DESIGN REVIEW COMMISSION AGENDA
OLD COUNCIL CHAMBERS
COEUR D'ALENE CITY HALL
710 E. MULLAN
Thursday December 17, 2015
12:00 pm

DR-6-15 – Decision Point: Cory Trapp with Longwell + Trapp Architects, on behalf of Hagadone Hospitality, is requesting the Design Review Commission's early design consultation for the design and construction of a 12-story, guest room tower addition to the existing Coeur d'Alene Resort Hotel in the Downtown Core (DC) zoning district.

SUBJECT: DR-6-15: REQUEST FOR A SECOND MEETING WITH THE DESIGN REVIEW COMMISSION FOR A 12-STORY, GUEST ROOM TOWER ADDITION, TO THE EXISTING COEUR D'ALENE RESORT HOTEL.

**RE: Coeur d'Alene Resort Guest Room Tower Addition
Design Review Submittal**

NORTH VIEW SKETCH UP:

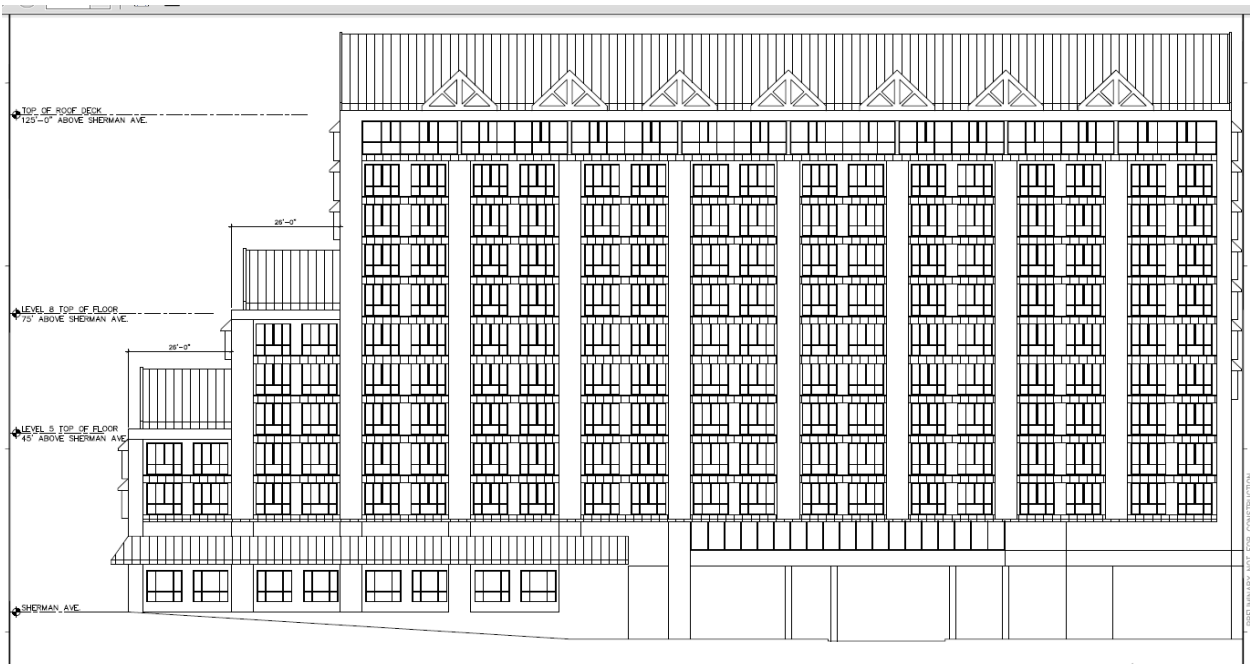
Commissioner Ingalls expressed concern regarding the rooms facing the west side and what the rooms looking from the east to the west will look like. He hoped that some design will break up that side of the building. Mr. Trapp said they too are concerned about the west side of the building and will incorporate some design to break up that side of the building. Mr. Ingalls said that he likes how the design of the building steps away from Sherman Avenue.

Include design elements that will break up the east side of the building, considerations for the sky bridge to include lighting, show glazing and the design aspects for pedestrians and bicycle connections from McEuen Park to City Park under the sky bridge.
